North Tuncurry Urban Release Area Biodiversity Certification Application

Response to public submissions

23 November 2022

Figure 3: Revised Master Plan (amending perimeter roads) as requested by the RFS

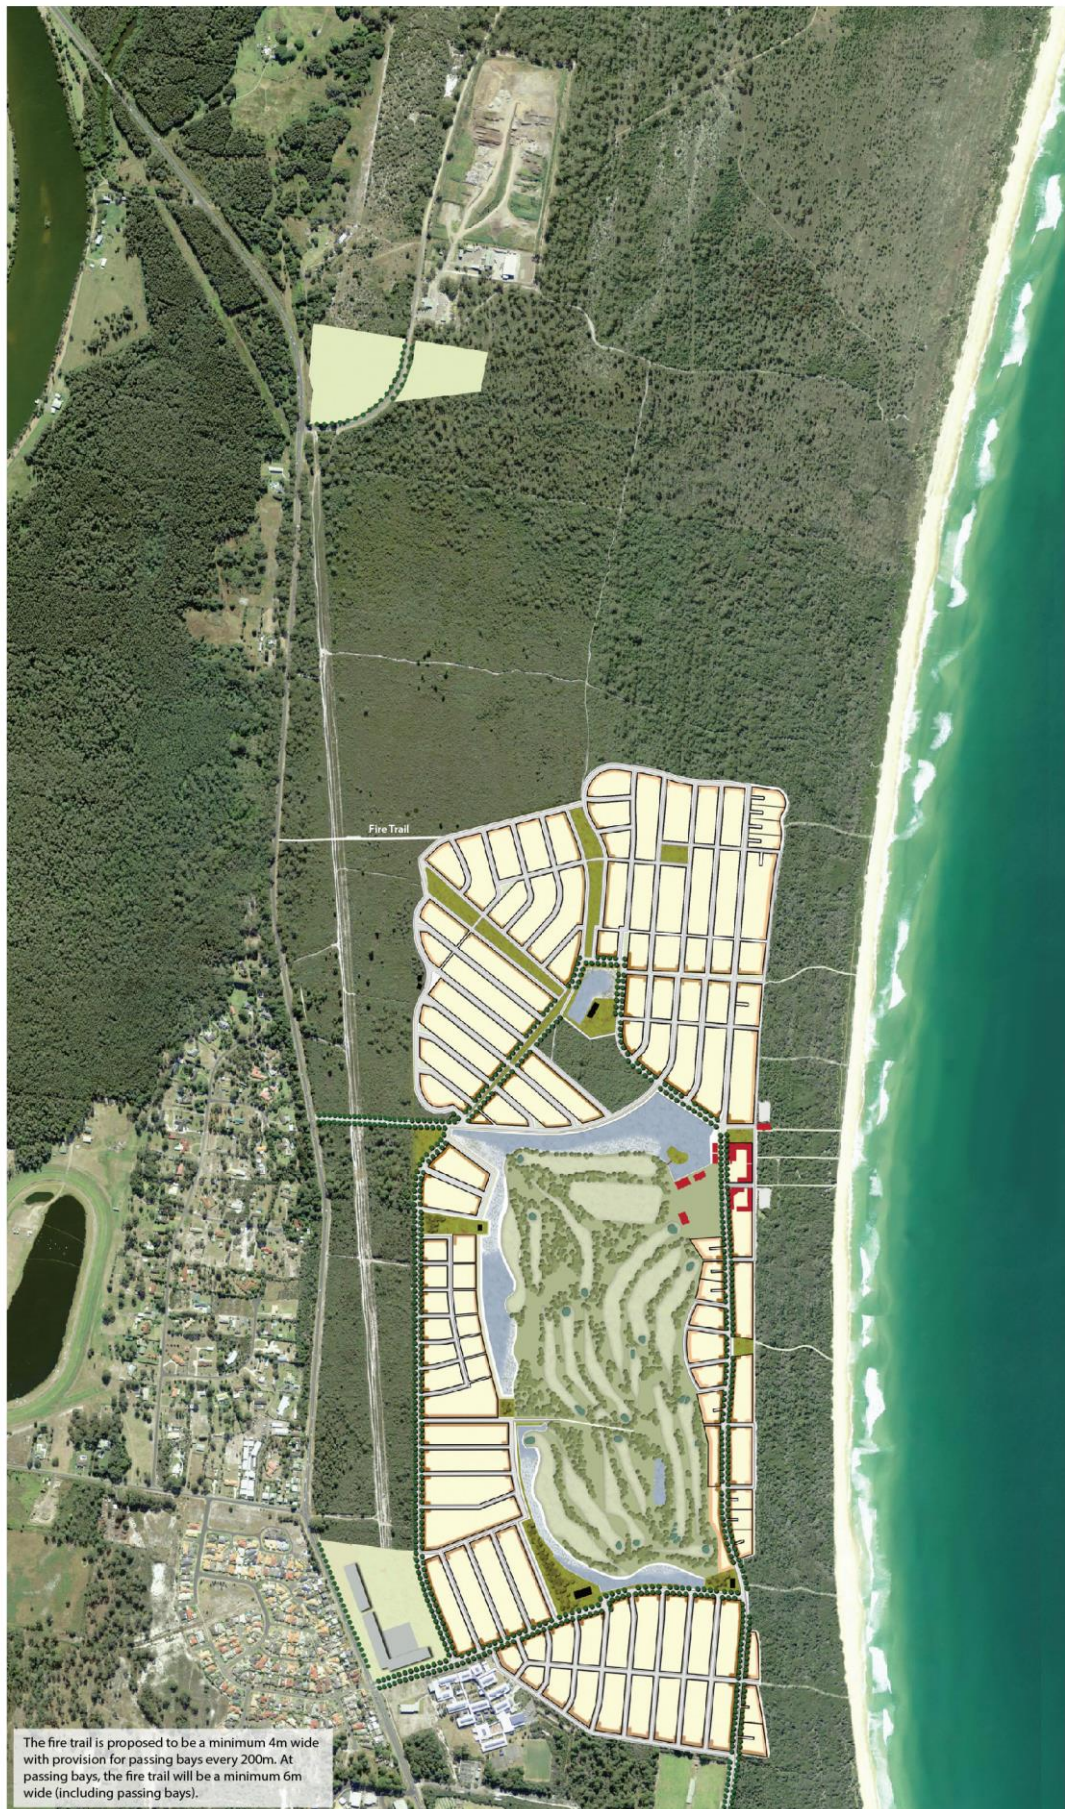
However, following a review of the relevant issues raised in the exhibition period, the Biocertification Assessment report will need to be updated to accommodate some minor amendments to the Master Plan raised by the Rural Fire Service. This will result in relatively minor changes to the overall credits required/credits generated and will not increase impacts to TMO. The BCAR will also be updated to make the measures taken to avoid and minimise impacts to biodiversity values during the extensive planning and consultation phase of the proposal clearer.

The revised Master Plan footprint is shown at Figure 3.
